Company	Trenz Electronic GmbH
PCN Number	PCN-20251217
Title	TE0813-02 DDR4 Update
Subject	BOM Change
Issue Date	2026-09-24

This change affects all Trenz Electronic TE0813 SoMs: TE0813-02*.

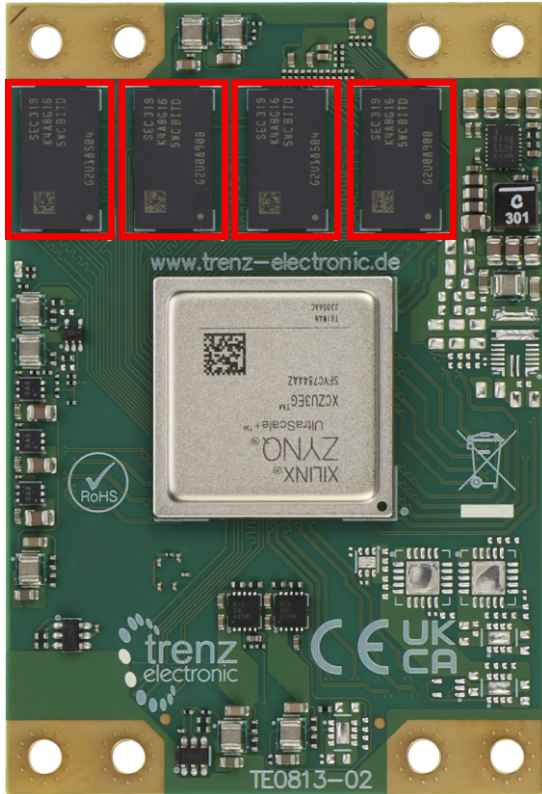
#1 Changed DDR4 SDRAM (U2, U3, U9, U12) from K4A8G165WC-BITDTCT to IS43QR16512A-075VBLL.

Type: BOM change

Reason: EOL of old DDR4.

Impact: New DDR timings may be considered in designs. DDR4 setup used in reference design is known to work still according to [ZynqMP DDR4 Memory Setup](#).

Locate DDR4 SDRAM (U2, U3, U9, U12) on top side of TE0813-02 PCB:

old	new
K4A8G165WC-BITDTCT	IS43QR16512A-075VBLI
